Duke Energy Corporation

McGuire Nuclear Station
12700 Hagers Ferry Road
Huntersville, NC 28078-9340
(704) 875-4800 OFFICE
(704) 875-4809 FAX

Subject: McGuire Nuclear Station, Units 1 and 2
Docket Nos. 50-369 and 50-370
Proposed Revision to Technical Specifications (TS)
TS 3.3.2 - Engineered Safety Feature Actuation System
(ESFAS) Instrumentation
TS 3.4.3 - Reactor Coolant System Pressure and
Temperature Limits
TS 3.4.12 - Low Temperature Overpressure Protection
System

Figure 3.4.3-1 RCS Heatup Limitations
(UNIT 1 ONLY)
(Without margins for Instrumentation Errors)
NRC REG GUIDE 1.99, Rev. 2
Applicable for the first 16 EFY

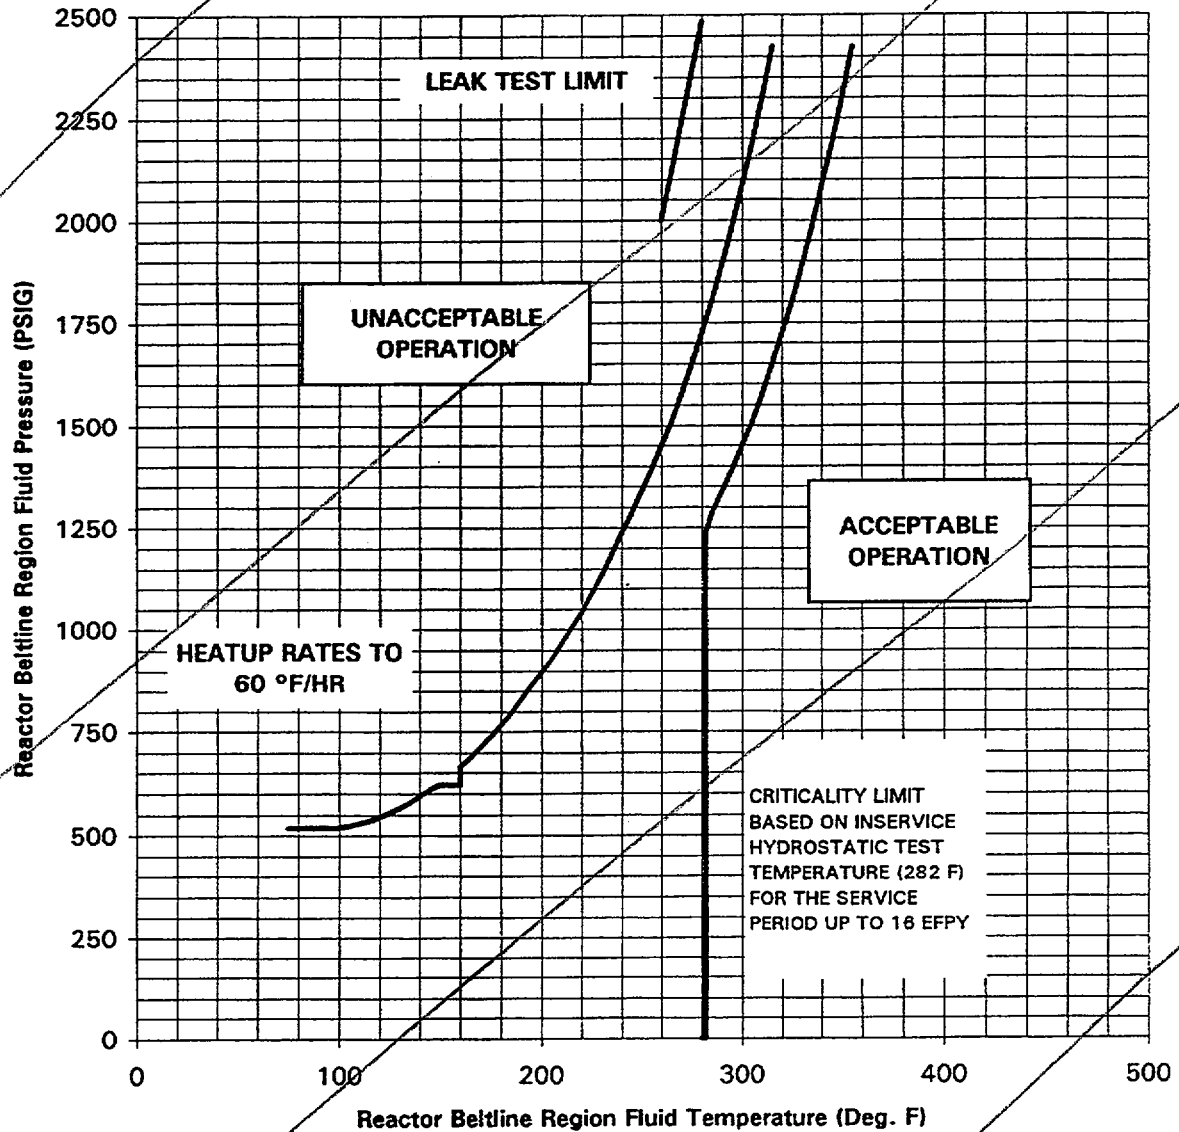
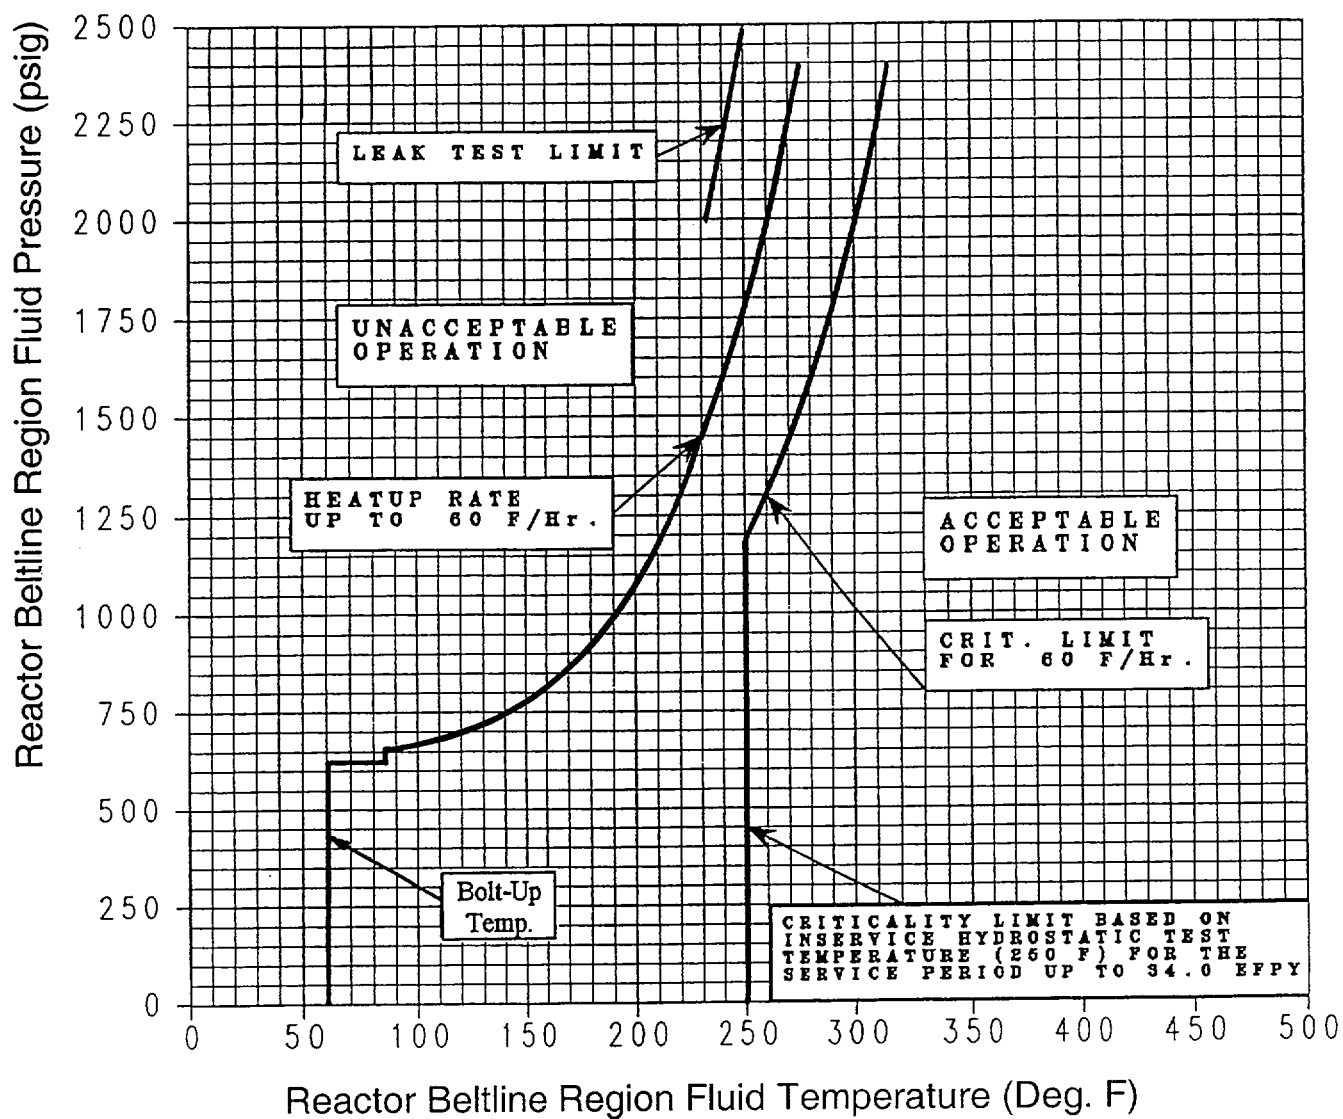
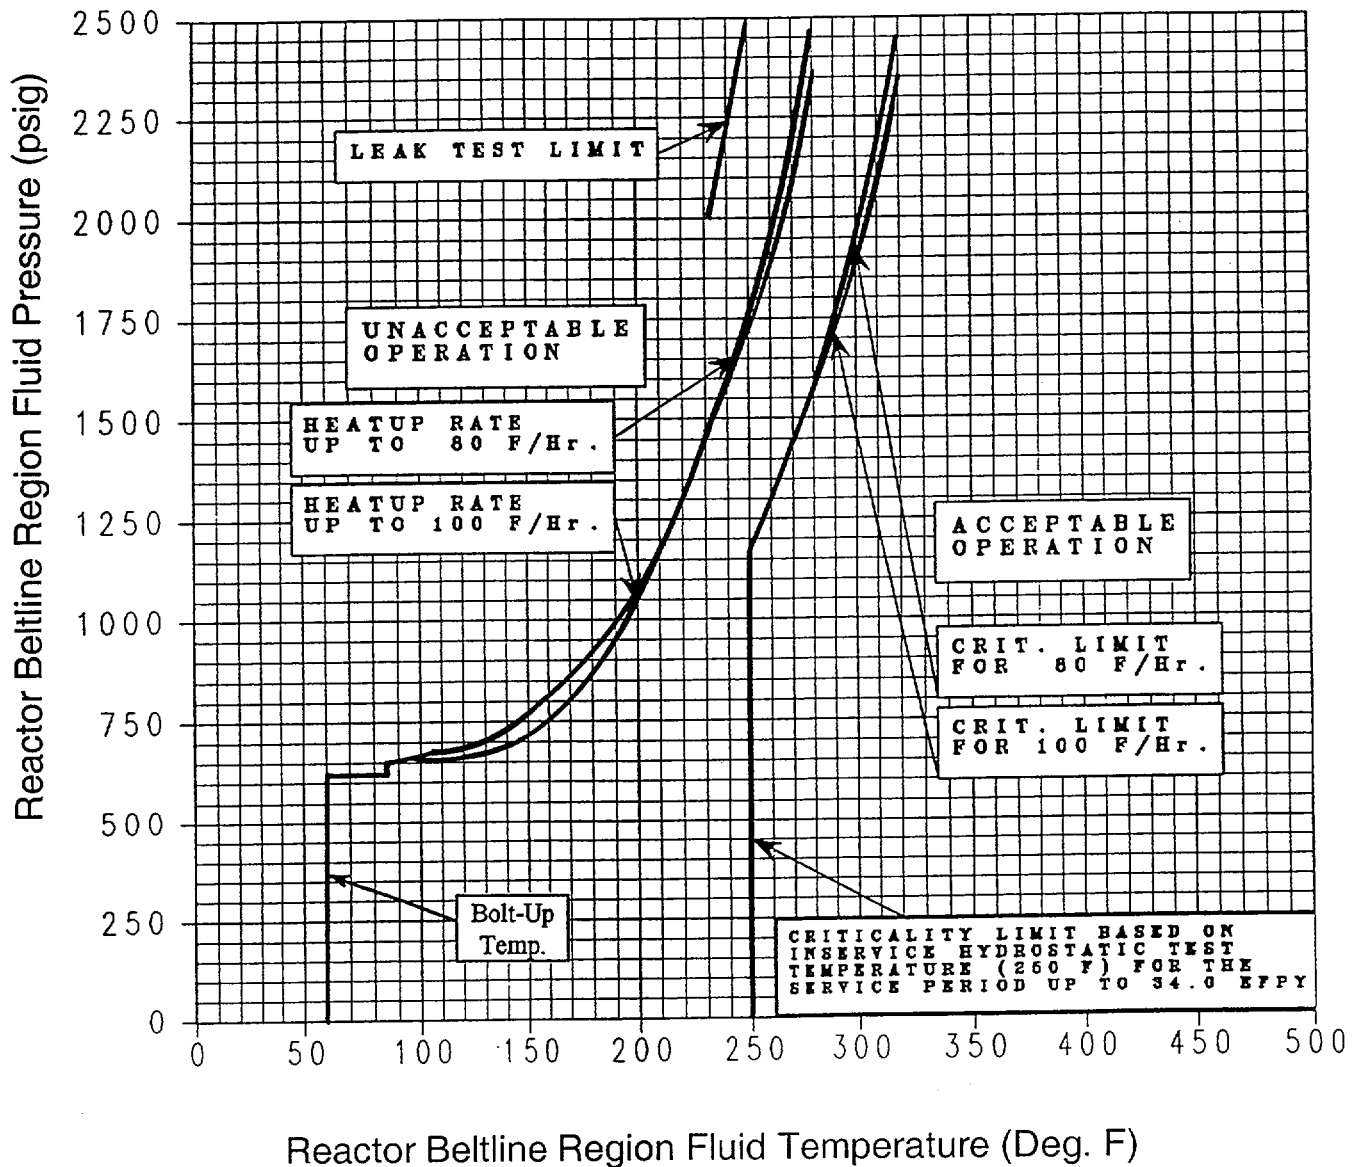
Replaced by next two figures

TS 3.4.3 is revised to reflect the new P/T limits which are effective to a maximum of 34 EFPY for Units 1 and 2. Figure 3.4.3-1 currently has two heatup figures, one for each unit. Figure 3.4.3-2 currently has two cooldown figures, one for each unit. Figure 3.4.3-1 will be replaced with four heatup figures (Figures 3.4.3-1 through 3.4.3-4), two for each unit. Figure 3.4.3-2 will be replaced with two cooldown figures (Figures 3.4.3-5 and 3.4.3-6), one for each unit. Limiting condition for operation (LCO) 3.4.3 is revised to refer to these new figures. The technical justification for this change is included in Section 3.2.

McGuire Unit 1 Reactor Coolant System Heatup Limitations (Heatup Rate of 60° F/hr)
Applicable to 34 EFPY (Without Margins for Instrumentation Errors)

McGuire Unit 1 Reactor Coolant System Heatup Limitations (Heatup Rates of 80 and 100° F/hr)
Applicable to 34 EFPY (Without Margins for Instrumentation Errors)

Figure 3.4.3-1 RCS Heatup Limitations
(Unit 2 Only)
(Without margins for Instrumentation Errors)
NRC REG GUIDE 1.99, Rev. 2
Applicable for the First 16 EFPY

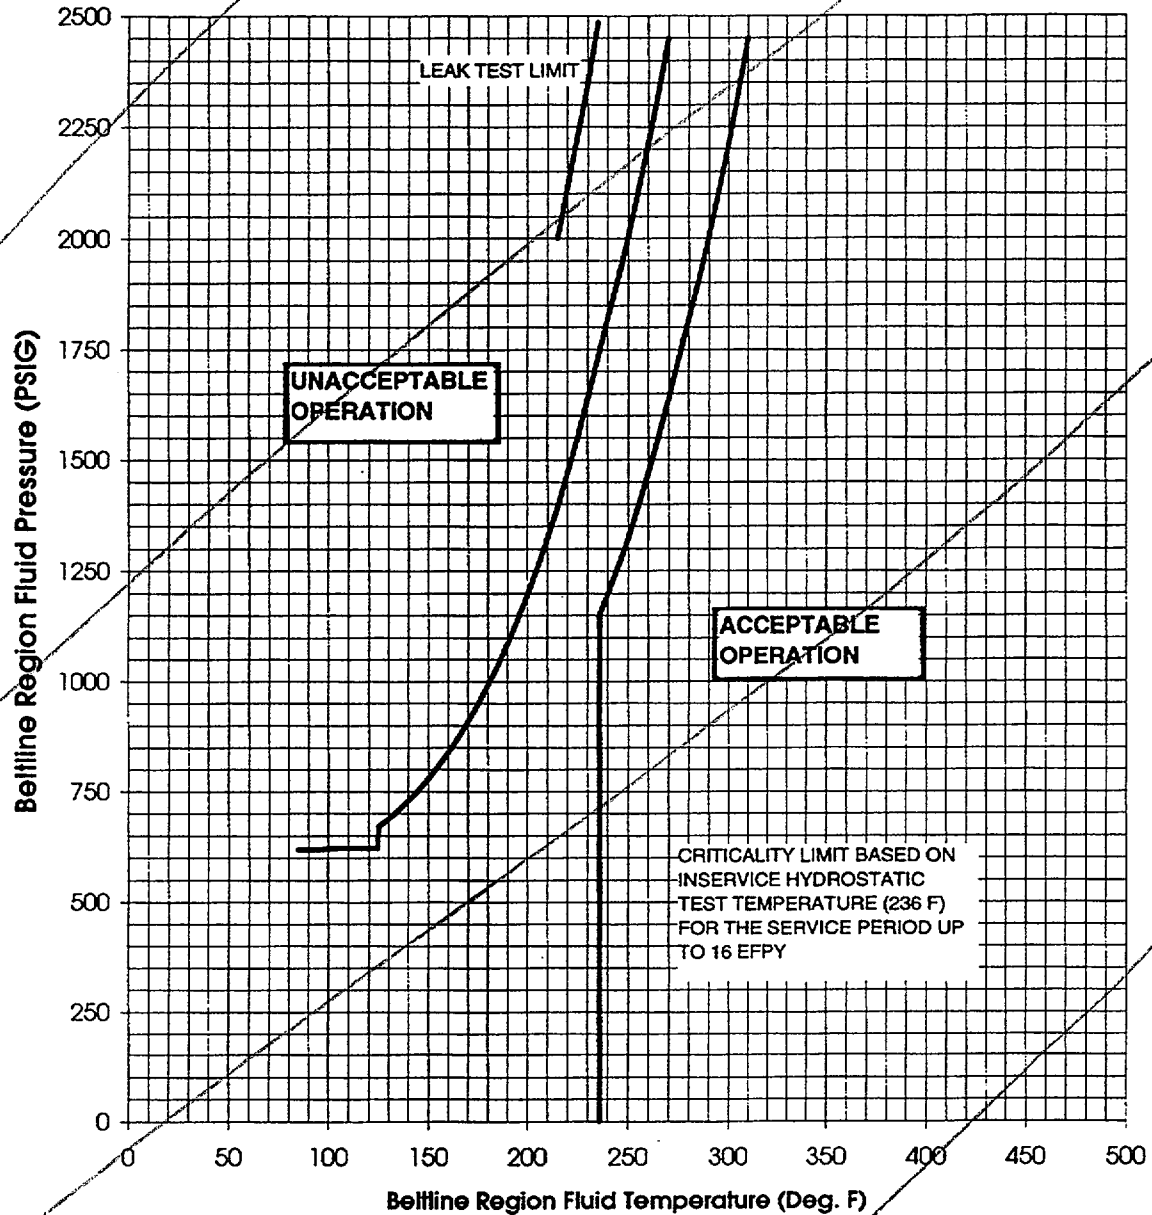
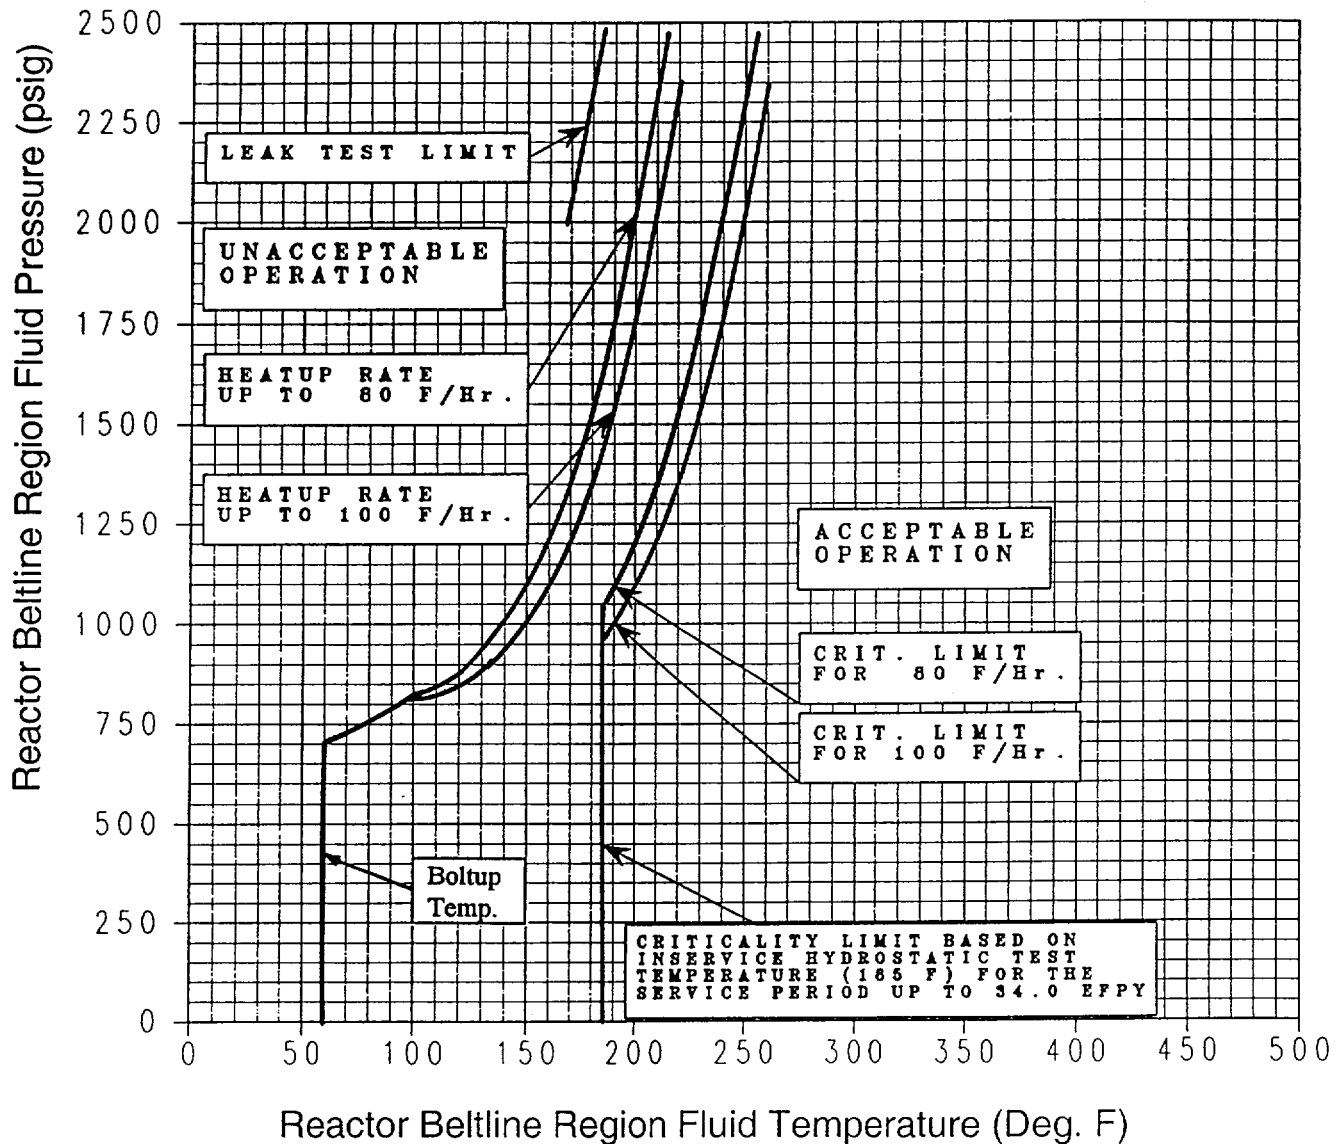
Replaced by next two figures

McGuire Unit 2 Reactor Coolant System Heatup Limitations (Heatup Rates of 80 and 100° F/hr)
Applicable to 34 EFPY (Without Margins for Instrumentation Errors)

Figure 3.4.3-2 RCS Cooldown Limitations
(UNIT 1 ONLY)

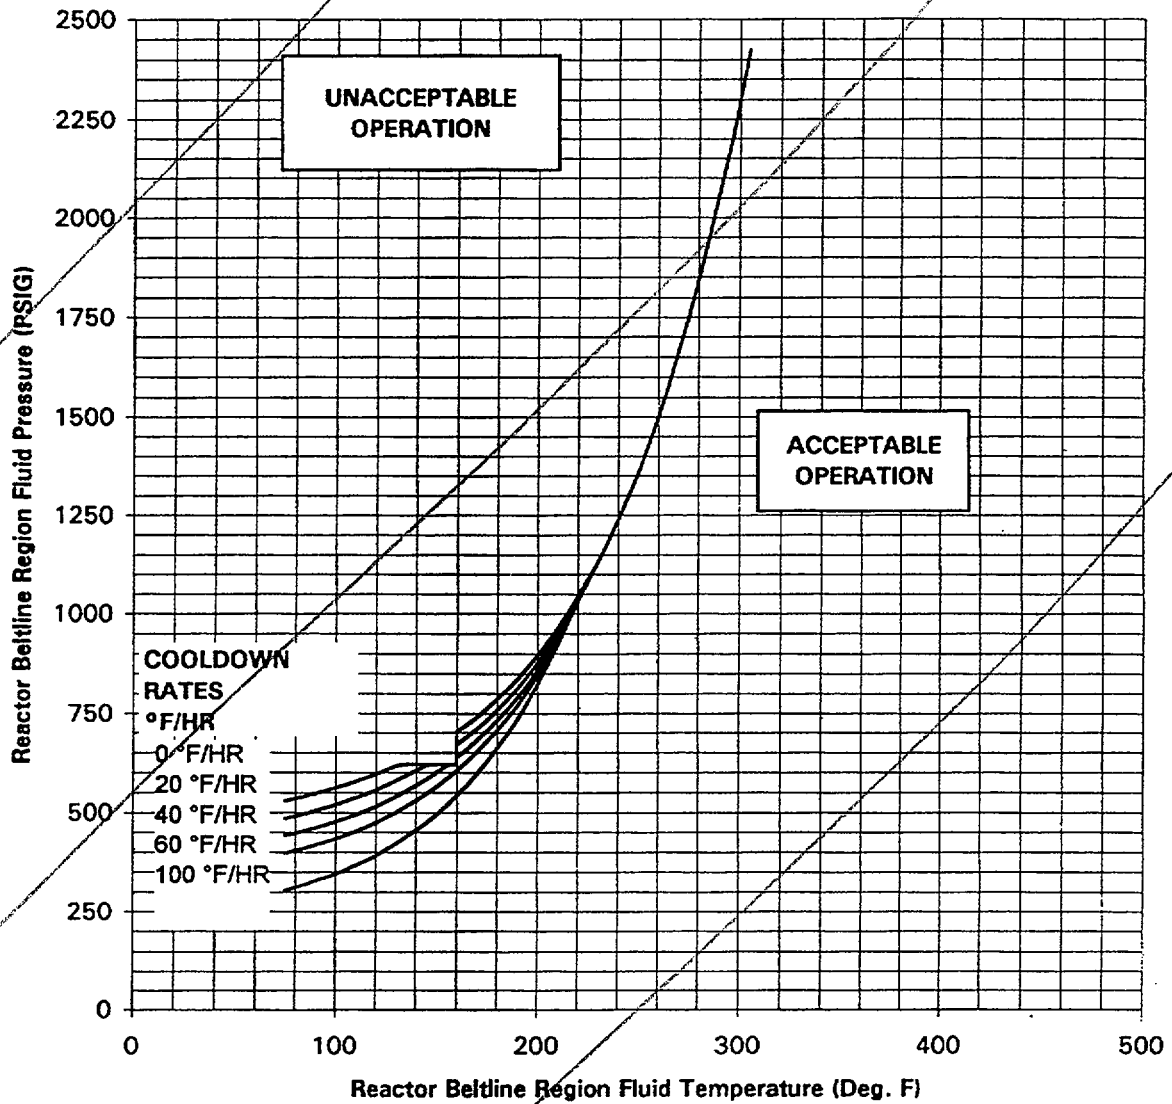
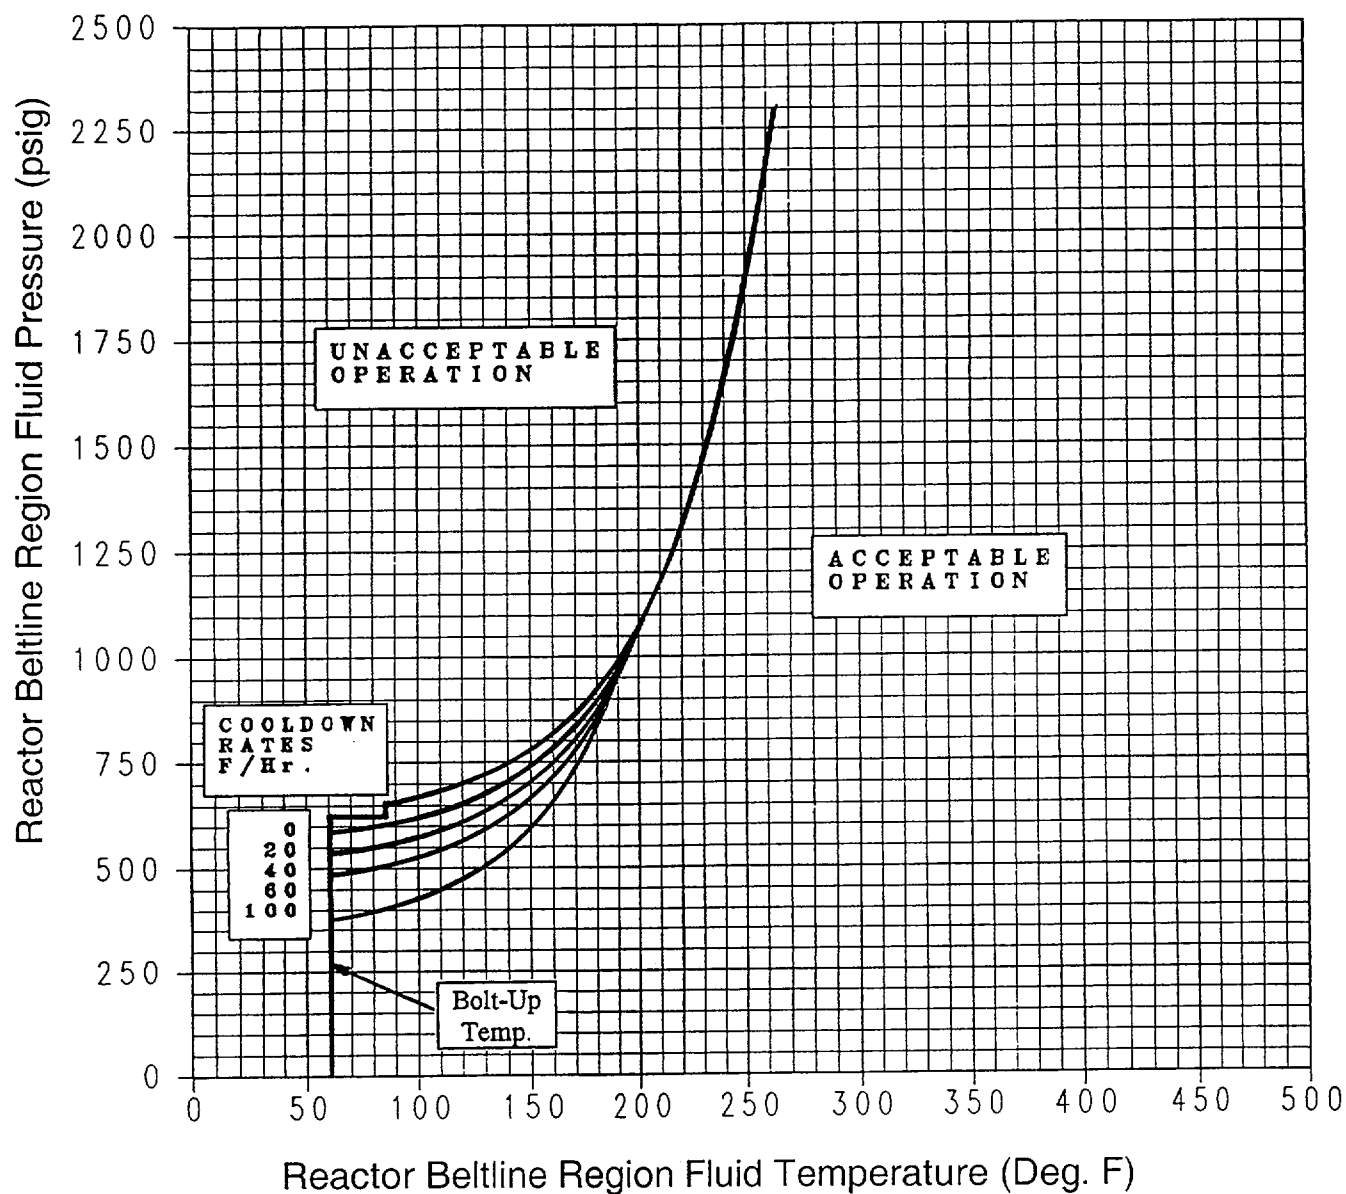
Replaced by next figure

McGuire Unit 1 Reactor Coolant System Cooldown Limitations (Cooldown Rates of 0, 20, 40, 60 and 100° F/hr) Applicable to 34 EFPY (Without Margins for Instrumentation Errors)
